Wastewater treatment - Membrane Bio-reactor (MBR)

Figure 1: Predicted inflows to Drouin WWTP (1:5 year ARI)

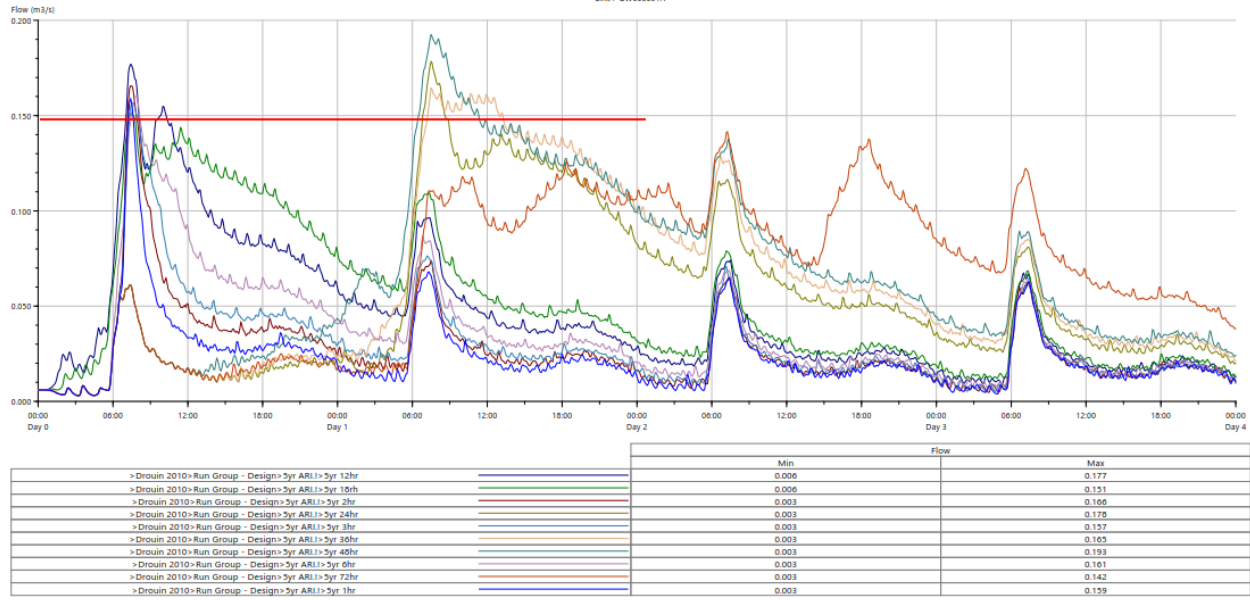
2) Please provide details of the Membrane Bio-reactor (MBR) contingency arrangements, such as additional freeboard or alternative facilities, for use as holding volume in emergency situations.

The freeboard in the MBR tanks is 350 mm (difference b/w top of concrete and the level of the overflow weir). The freeboard in the MBR tanks is designed to provide reliable operation and ensure that effluent is not spilled via the overflow if there is a process upset or pump shutdown. However; as the plant has the ability to divert all flows to the lagoons upstream of the MBR, this freeboard will not be required for storage of emergency influent volumes. Should the levels in the MBR exceed the high level value, all excess flow not able to be treated by the MBR will be diverted to the lagoons. Therefore the existing lagoon treatment plant facility will cater for emergency holding situations.

An assessment has been completed to determine the excess flows and volumes that will be diverted to the lagoon treatment plant and stored in the winter storage lagoon under all 1:5 year ARI storm events. Table 1 lists the total volume required in the winter storage to cater for these events, and also the total duration of the excess flow event when emergency storage volume will be utilised.

Figure 1 shows the modelling output from the InfoWorks network model. Flows greater than 12.6ML/d (roughly 150 l/s) must be stored in the lagoon system, and is shown by the red line.

The winter storage at Drouin has a total capacity of 230 ML. The working capacity that can be returned back to the MBR plant via the lagoon recycle is approximately 150 ML. The proposed volume that needs to be set aside for emergency inflows from 1:5 year ARI events is less than 1% of the total capacity of the lagoon. It is recommended that Gippsland Water operate the lagoons to always have winter storage at a maximum capacity of 95%. This will allow sufficient storage for the emergency volume, as well as providing further operational flexibility to best manage returning any emergency inflows back to the MBR plant over a period of time while maximising the energy efficiency of the overall process.

Figure 2: Flow split between MBR and lagoons vs time of day (48 hour cycle shown)

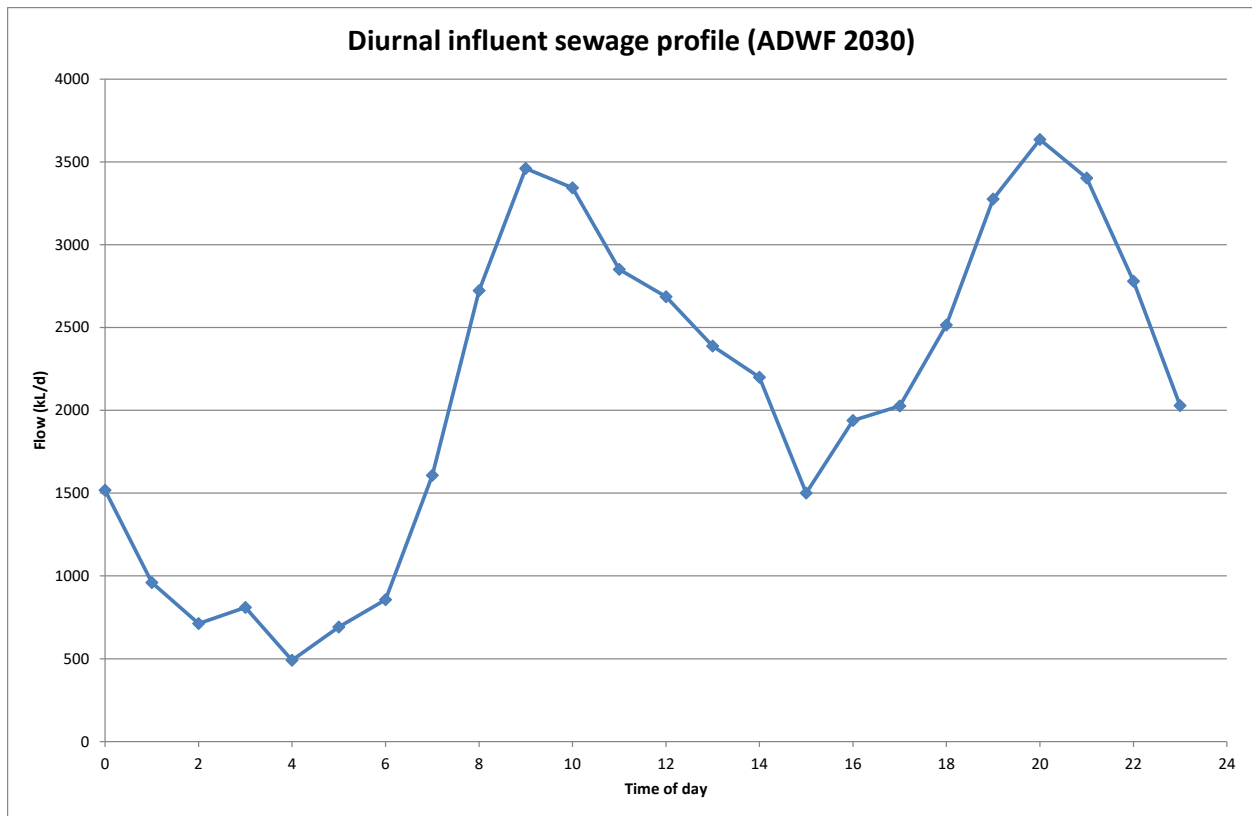
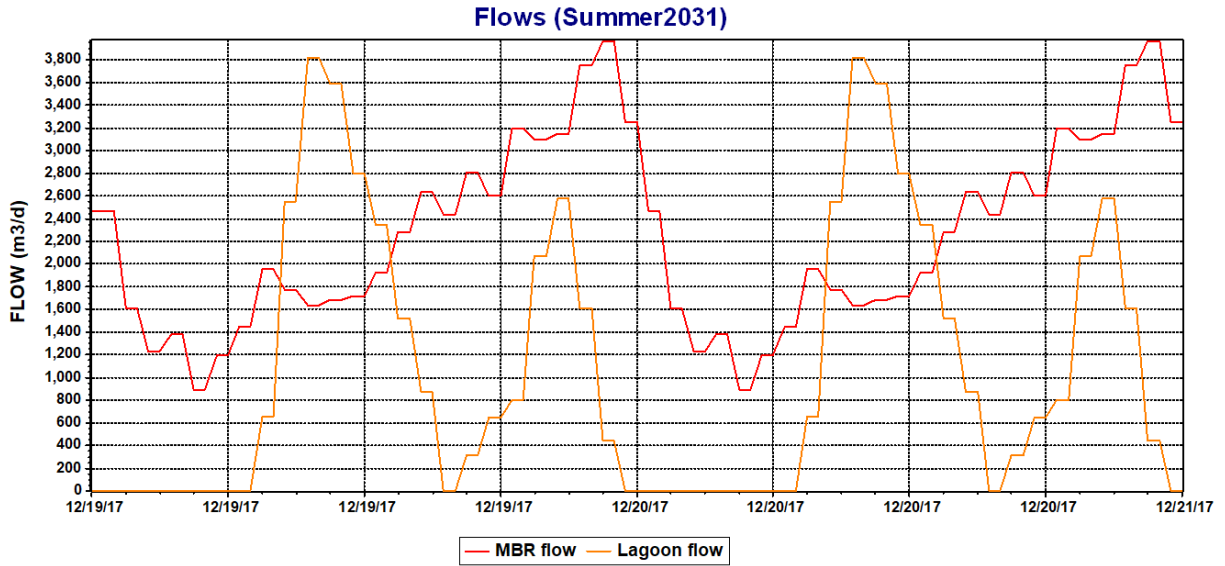
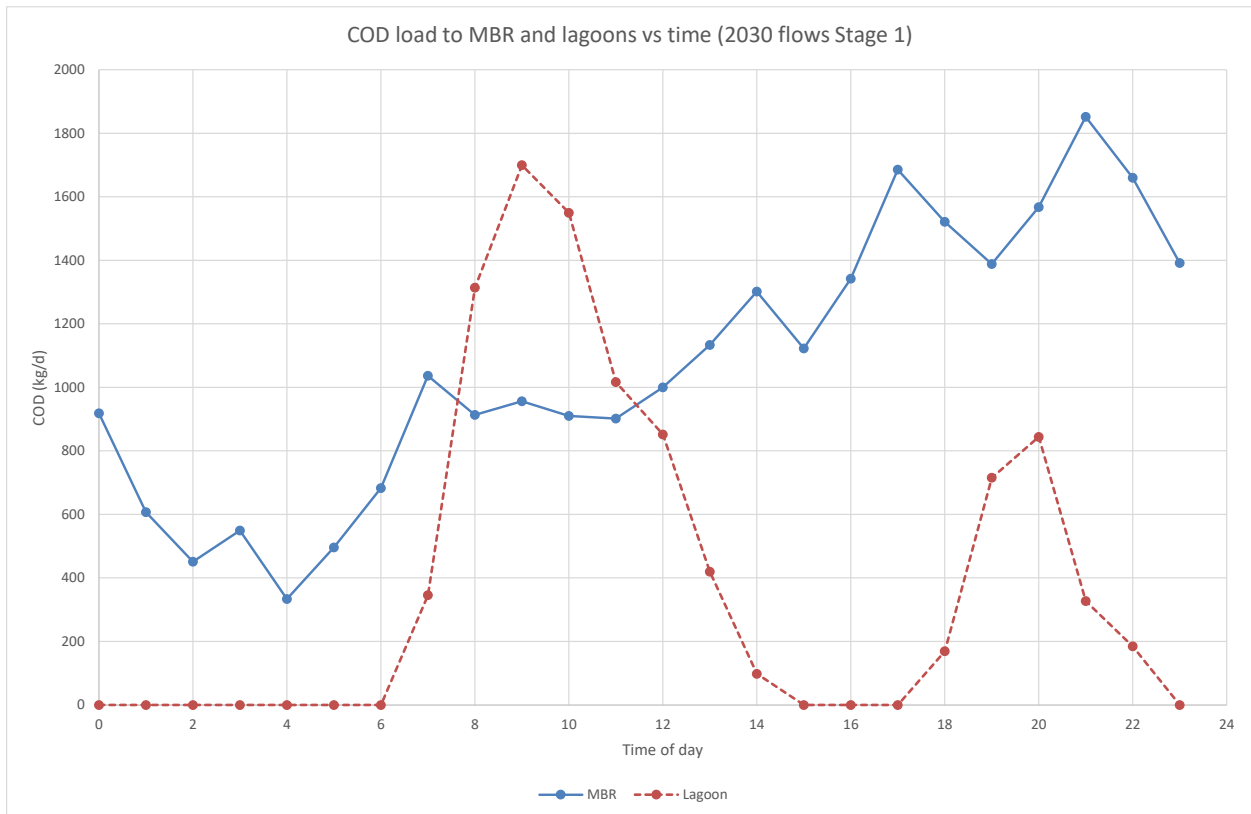
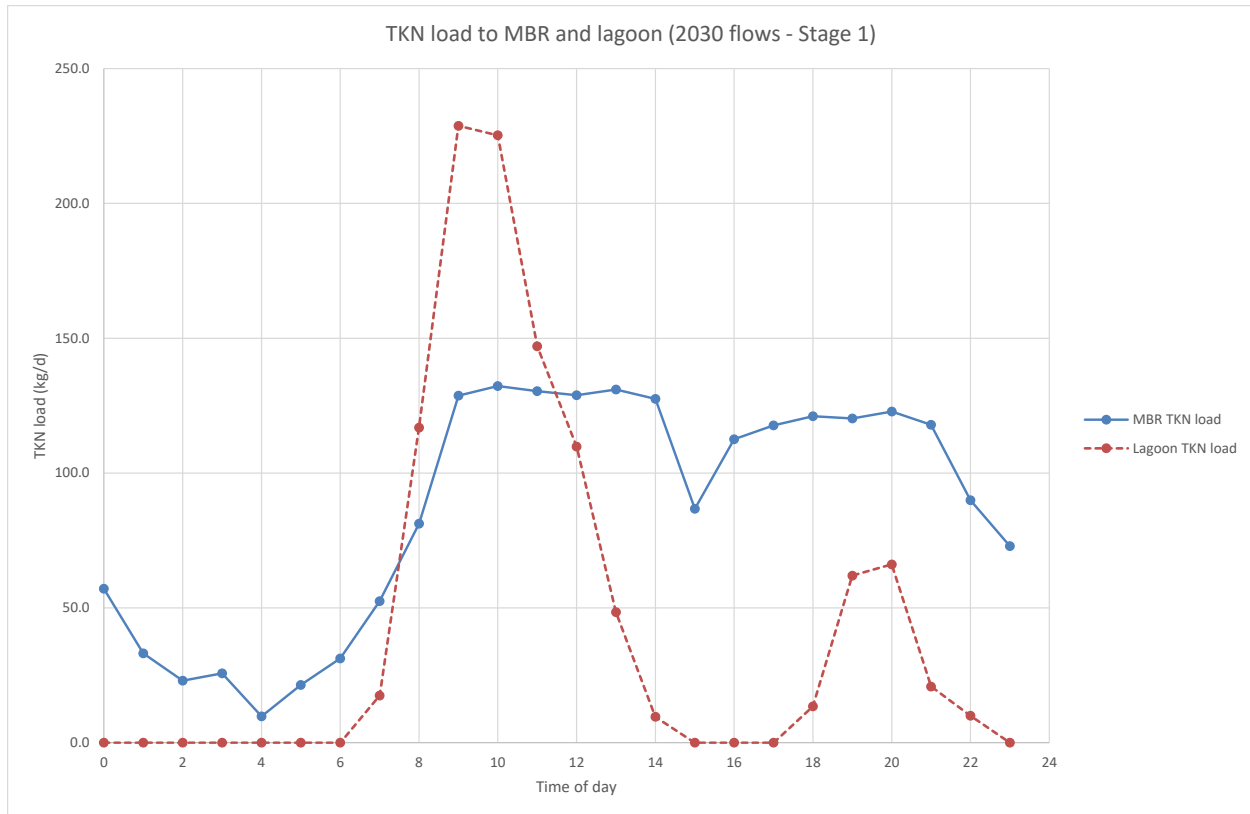
3) Please provide details justifying application of a peak wet weather flow factor of 3 x average dry weather flow rate and/or facilities for peak flow equalisation during periods of peak demand.

However, as there will be two treatment plants operating in parallel at Drouin (i.e. the existing lagoons and the MBR system), it was determined that a peak hydraulic capacity of 3 x ADWF would provide sufficient capacity for the MBR system, with the lagoons able to take any additional flows under peak wet weather conditions. Anything treated by the lagoon system and not used for irrigation, can be

returned to the MBR after the wet weather event via the lagoon recycle system for additional treatment prior to discharge.

Under typical operating conditions, there will be a time-based flow split between the lagoons and the MBR system. The aim of this approach is to minimise the variation in the TKN loading to the MBR system, so that its settings can be optimised for nitrogen removal, in terms of minimal effluent nitrogen for minimal energy usage. Figure 1 shows the diurnal profile of the influent to the Drouin plant. The evening diurnal peak is actually higher than the morning peak as the main industrial contributor (Pure Harvest) discharges most of its wastewater during this time. This also increases the COD load of the evening peak, but does not significantly increase the TKN load during the evening peak. Figure 2 shows how the flows to the MBR and lagoon will vary with time of day. Figures 3 and 4 show the time-based variation in the COD and TKN loads respectively to the MBR and lagoon. The effect of the increased COD load during the evening is due to the Pure Harvest discharge, while the TKN load to the MBR remains relatively constant for most of the day.
